AMENDMENTS TO THE DRAWINGS:

REMARKS

This amendment is responsive to the Office Action dated April 10, 2006. Claims 1 - 25 are pending in the application. Claims 10 - 12 and 14 - 25 have been withdrawn from consideration. Claims 1 - 9 and 13 have been examined and have been rejected. Reexamination is respectfully requested in light of the foregoing amendments and following remarks.

FIG. 12

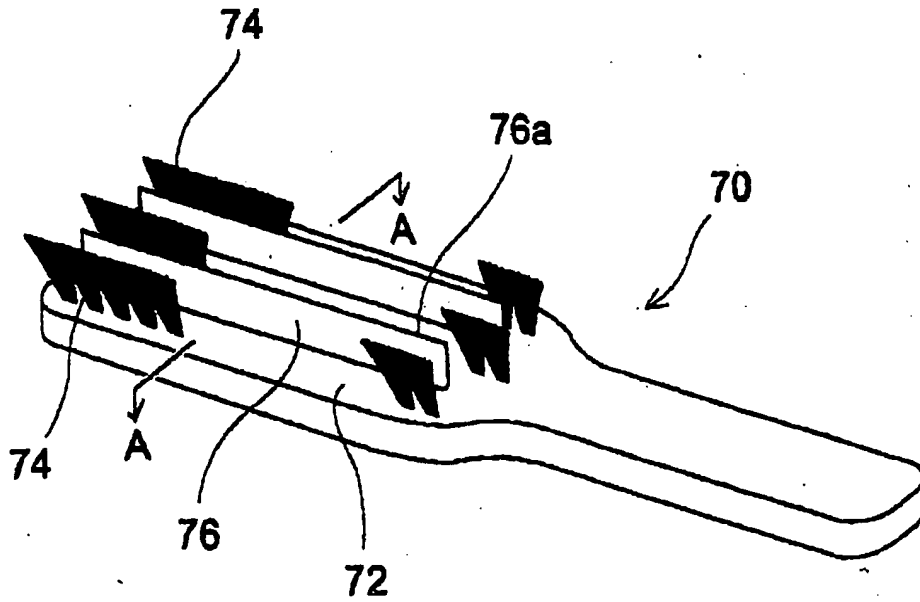
In Figure 12, the legend Prior Art has been added.

Figures 12 - 14 have been amended to state that they depict prior art.

PRIOR ART

FIG. 13

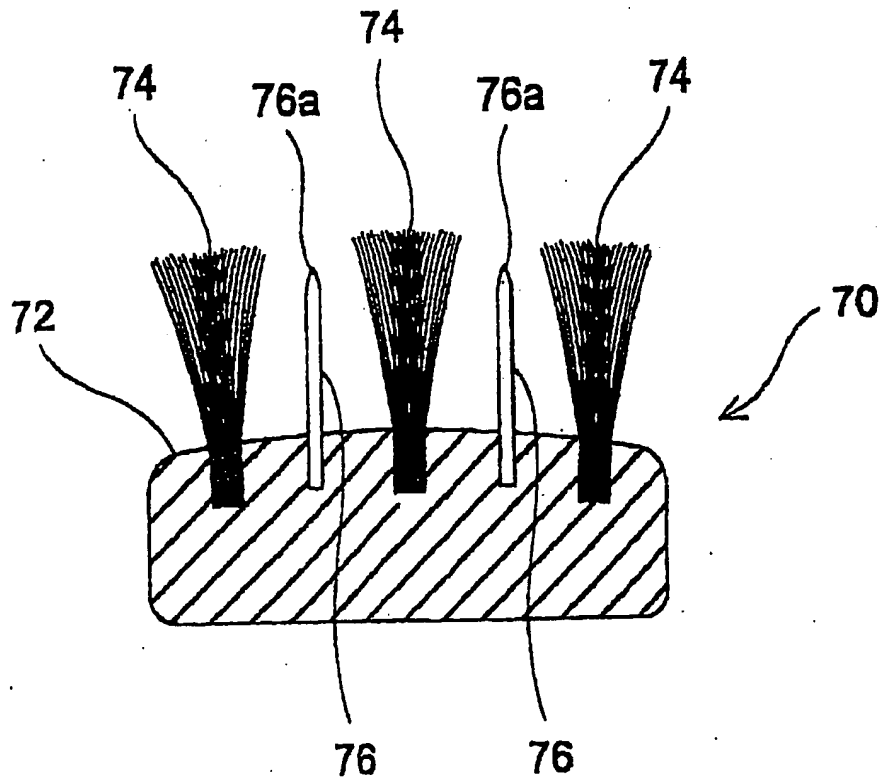
In Figure 13, the legend Prior Art has been added.

PRIOR ART
